DRAINAGE PLAN
HARBISON AUTO SALES
2027 SOUTH LAMAR BLVD.
AUSTIN, TEXAS

REPLACEMENT SHEET

SITE PLAN RELEASE: SHEET 5 OF 7

FILE NUMBER: SP-03-0469C REGISTRATION DATE: 02/14/04

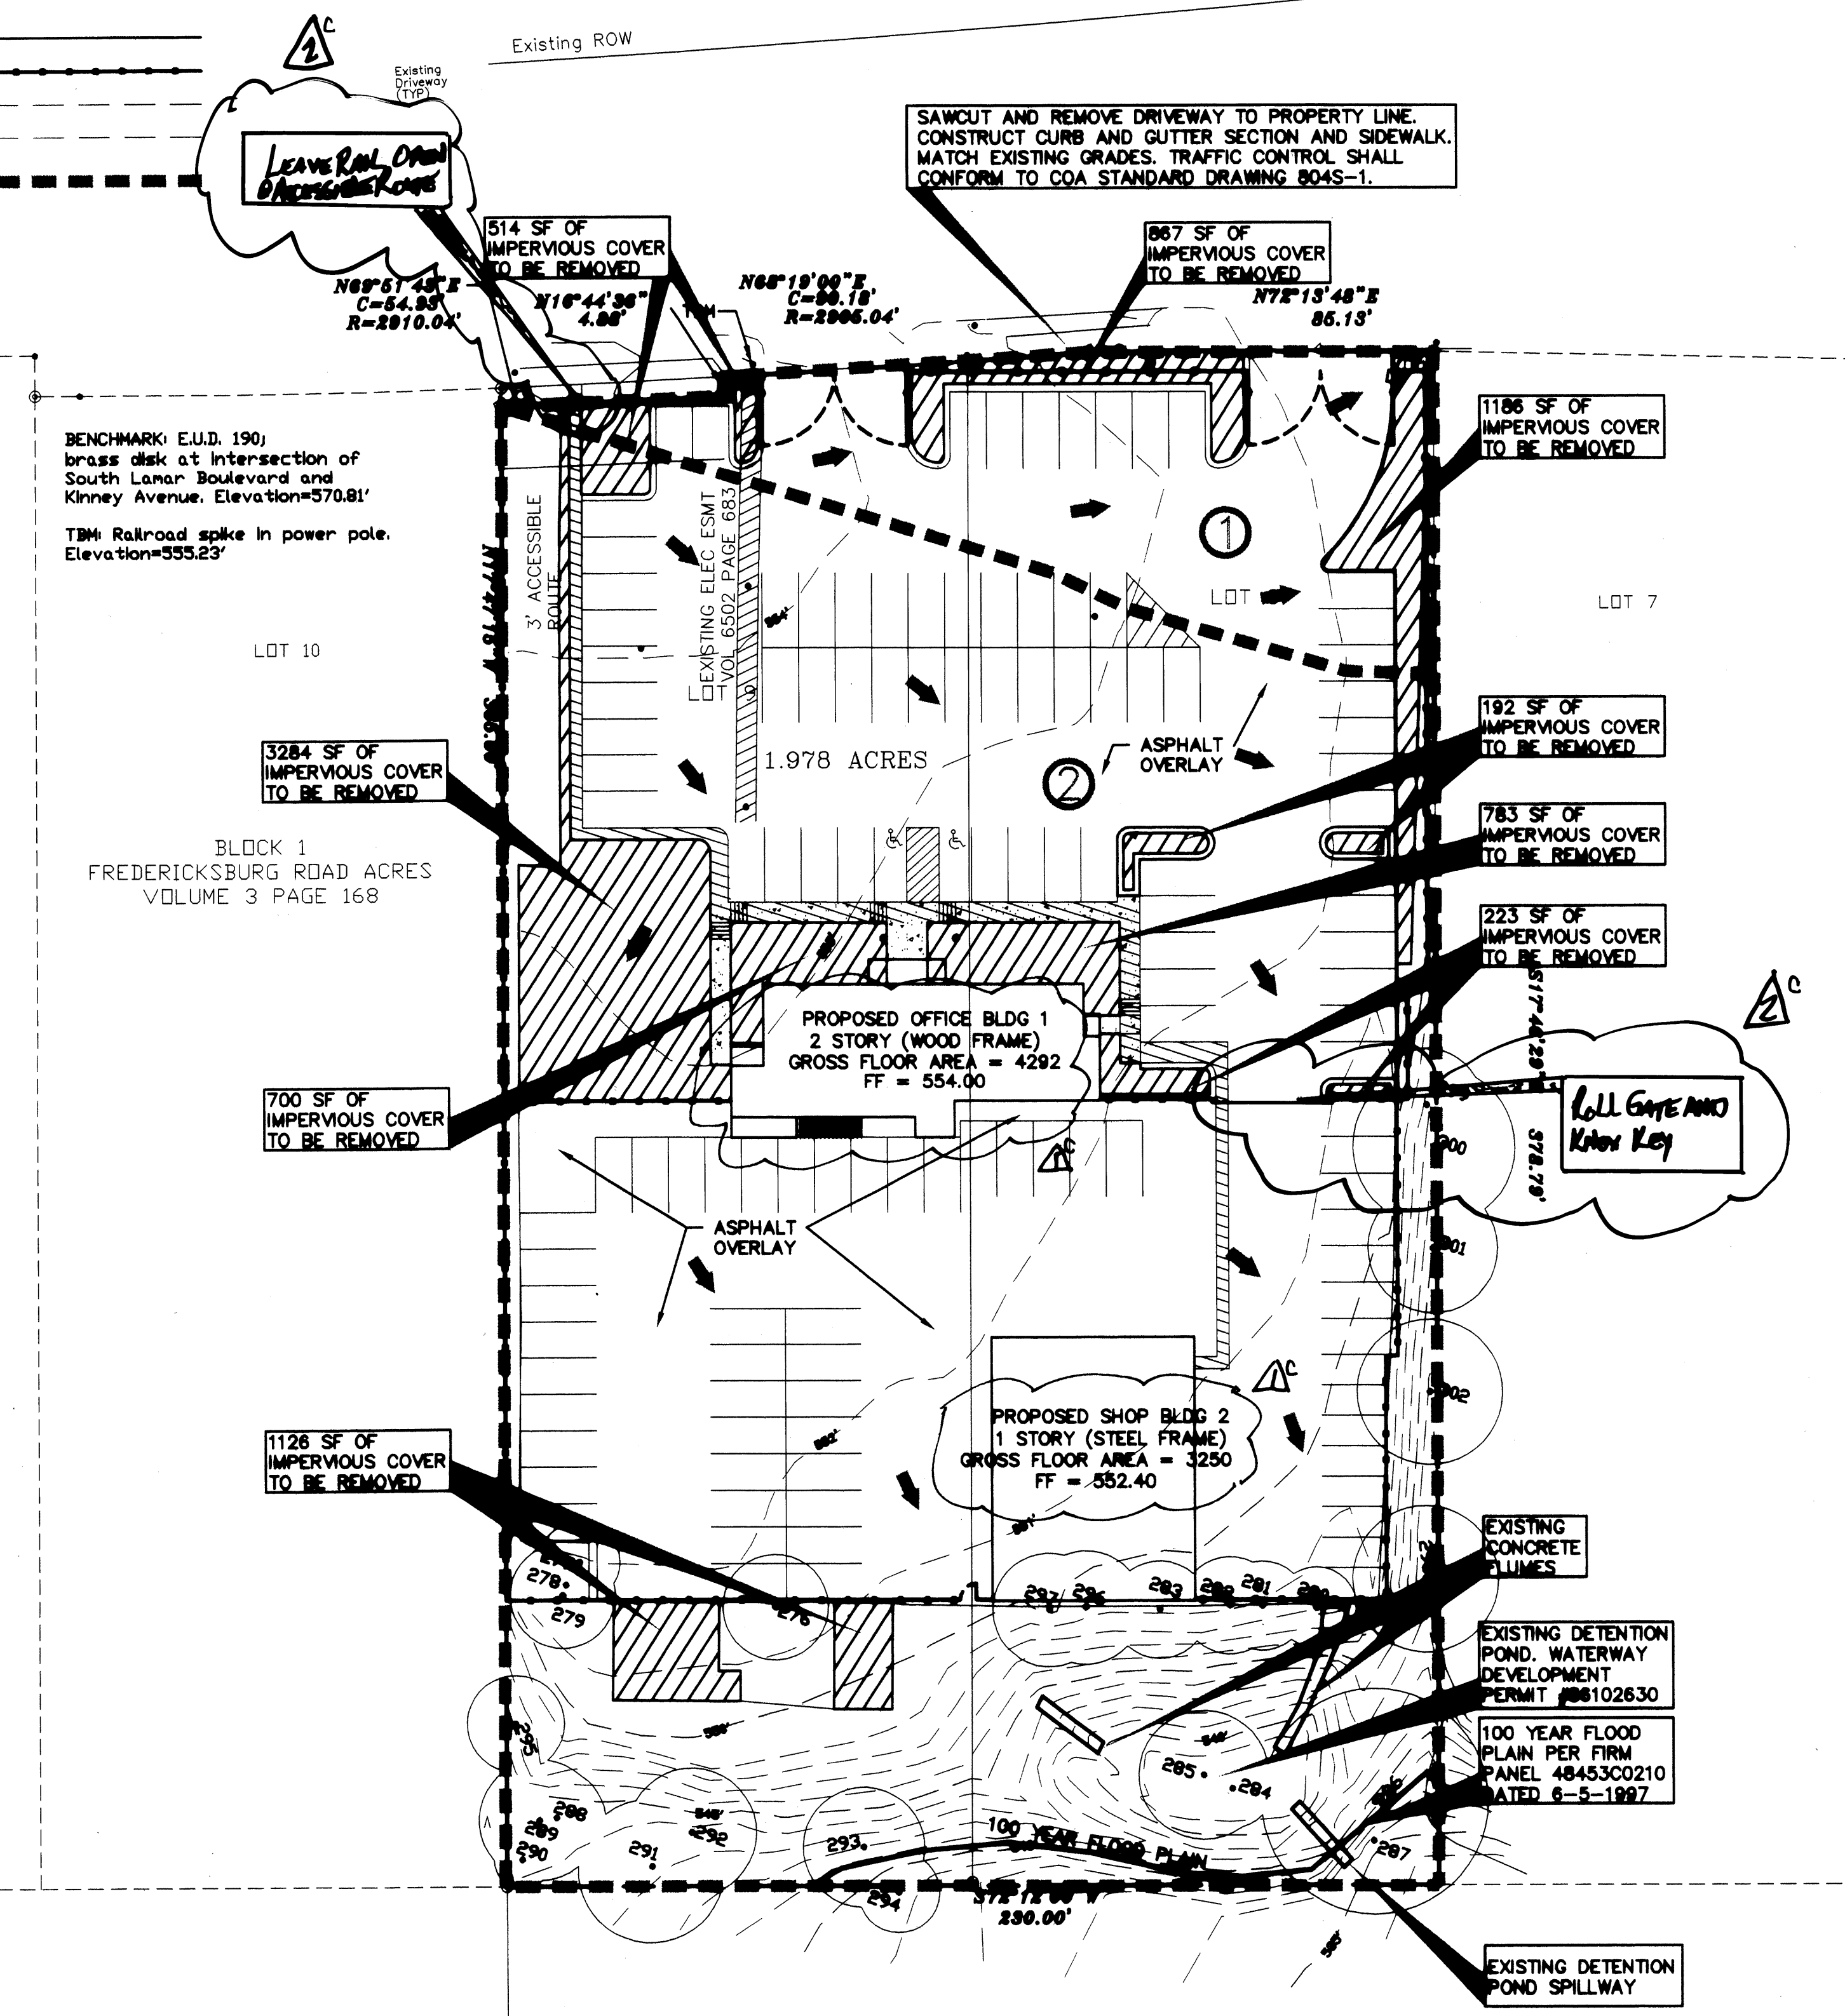
7-25-05	REV	DATE	APP	COMMENT
7-9-04	KEW	DATE	BY	APP
ADD EXTERIOR STAIRS				
BLDG 2, ADD EXTERIOR STAIRS				
ADD 46.5 SF BLDG 1, 250 SF				
ADD 46.5 SF BLDG 1, 250 SF				
APPROVED FOR: KENNETH WATKINS, P.E.				
DRAWN BY: KEW				
DATE: OCTOBER, 2003				
SCALE: 1" = 30'				
PROJECT NUMBER: 5005

THE REDEVELOPMENT OF THIS SITE RESULTS IN A NET DECREASE IN IMPERVIOUS COVER AND A RESULTING REDUCTION IN STORMWATER RUNOFF. THEREFORE, NO ALTERATIONS TO THE EXISTING STORMWATER DETENTION SYSTEM ARE PROPOSED.
